# UNITED STATES PATENT AND TRADEMARK OFFICE

APPLICATION NO.	FILING DATE	FIRST NAMED INVENTOR	ATTORNEY DOCKET NO.	CONFIRMATION NO.
10/786,131	02/26/2004	Hiroshi Okamoto	1131-0501P	3478

**Office Action Summary**

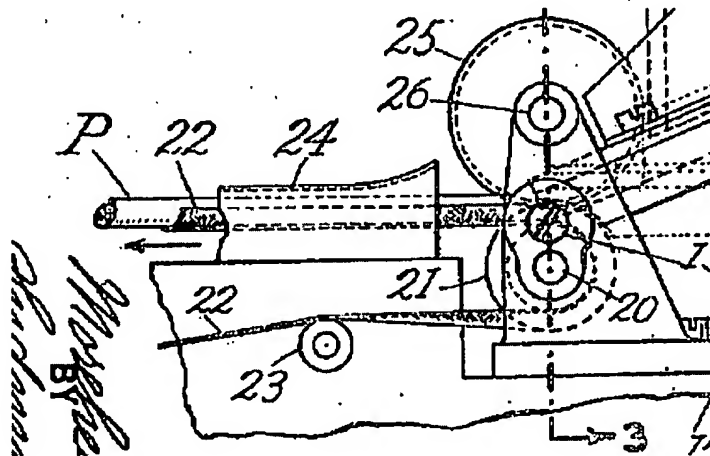
3. Claims 1, 2, and 3 are rejected under 35 U.S.C. 103(a) as being unpatentable over US 1885943 to Patterson in view of US 2593284 A to Ewell.
4. Regarding applicant claims 1 and 2, Patterson illustrates a device using a garniture tape to wrap a rod shaped article that employs a forming guide that bends the garniture tape into an arc, thus continuously wrapping the continuous rod with paper supplied to the garniture tape, and a roller (guide member) that is upstream of the rod wrapping section. Patterson's roller is shown to have a shape that is convex in reverse to the bend in the garniture tape caused by the forming guide (Figure 1 as seen below, element 21). This roller, having a similar cross section, as the guide member described

in the instant application, would offset an incremental tension produced upon the tape edges as the tape travels through the rod wrapping section (Figure 1, 24).
